**County of Loudoun**  
**Department of Planning**

**MEMORANDUM**

**SUBJECT: ZMAP 2009-0006 & SPEX 2009-0026**  
**Morley Corner – Temple Baptist Church and School 2<sup>nd</sup> Referral**

**Figure 2 and 3: Noise Survey Measurements**

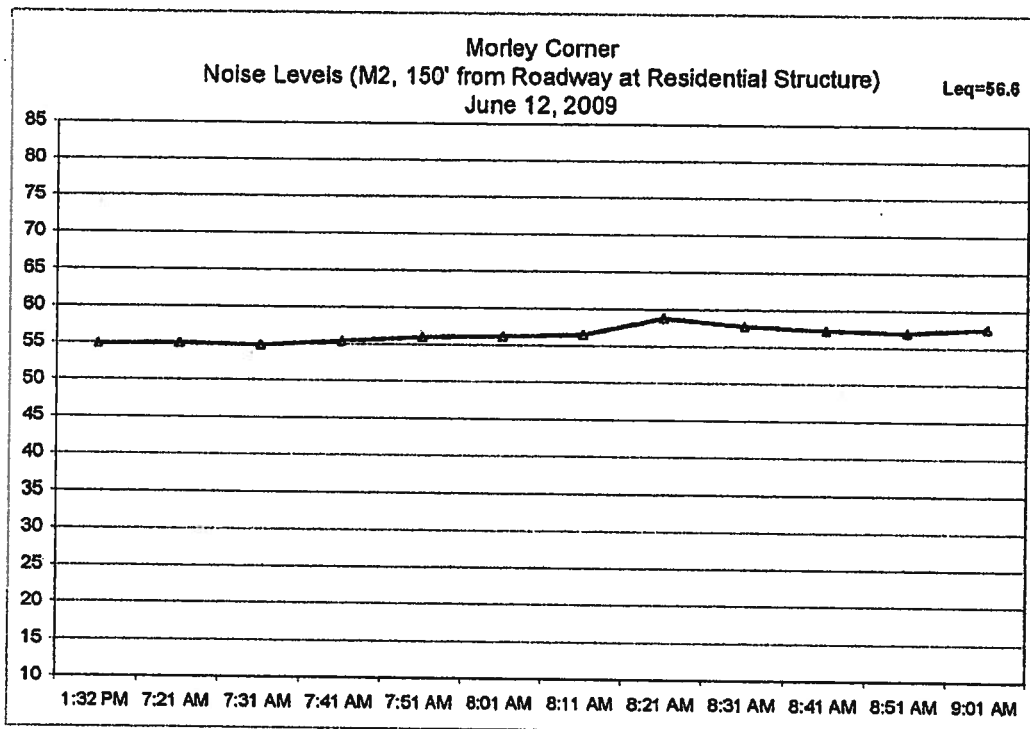
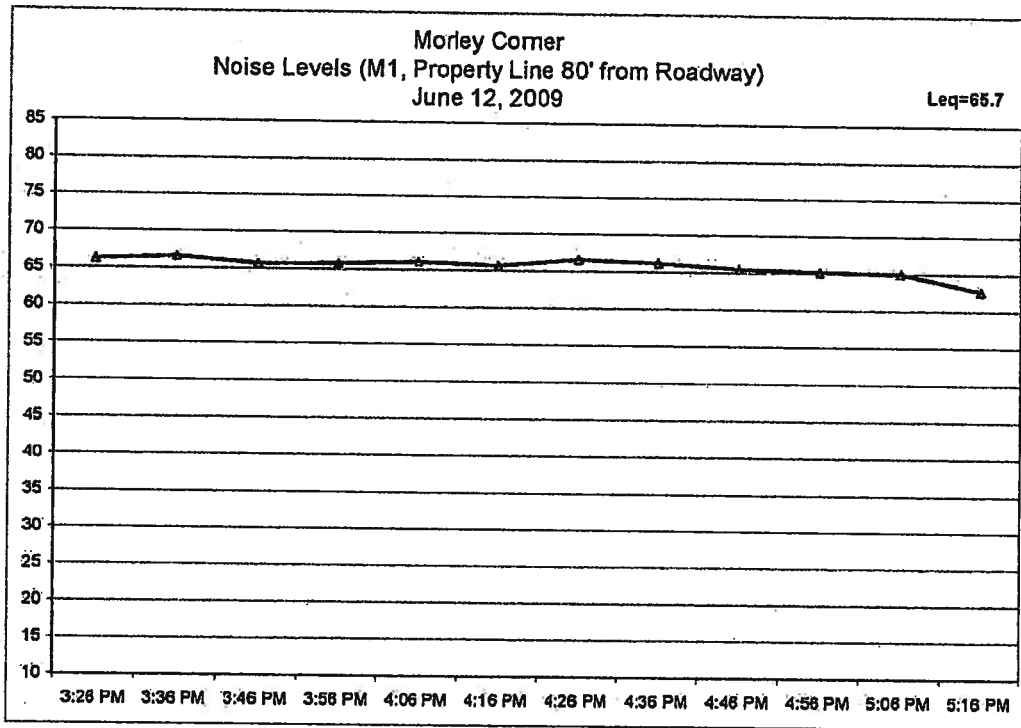
A chart showing the measured 2-hour noise levels as well as the 10-minute variation for the three measurements is enclosed in the appendix (Figure 2 and 3 Noise Survey Measurements – Results).
